UNITED STATES PATENT AND TRADEMARK OFFICE

APPLICATION NO.	FI	LING DATE	FIRST NAMED INVENTOR	ATTORNEY DOCKET NO.	CONFIRMATION NO.	
10/691,213 10/22/200		10/22/2003	Alfons Resing	09197-US	8365	
30689	7590 03/10/2006			EXAMINER		
DEERE & (KOVACS, ARPAD F			
MOLINE, II		LACE		ART UNIT	PAPER NUMBER	
				3671

DETAILED ACTION

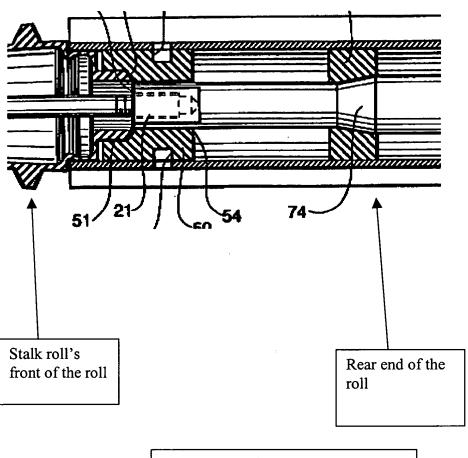
Bich discloses as shown below:

a roll body (starting at front auger ref 30 and ends at rear end of stalkroll ref 40), drivers (unnumbered driver at auger 30, and flutes ref 43);

driver inner edge is adjacent the boy (see fig 3);

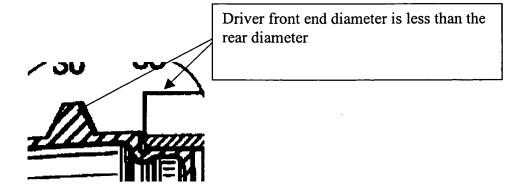
body front end diameter is greater than the rear end diameter of the body (see fig 3, the rear edge of auger 30 is slightly higher than the body 40);

the driver front end diameter is less than the rear diameter (see unnumbered front driver is slightly below the rear driver 43).
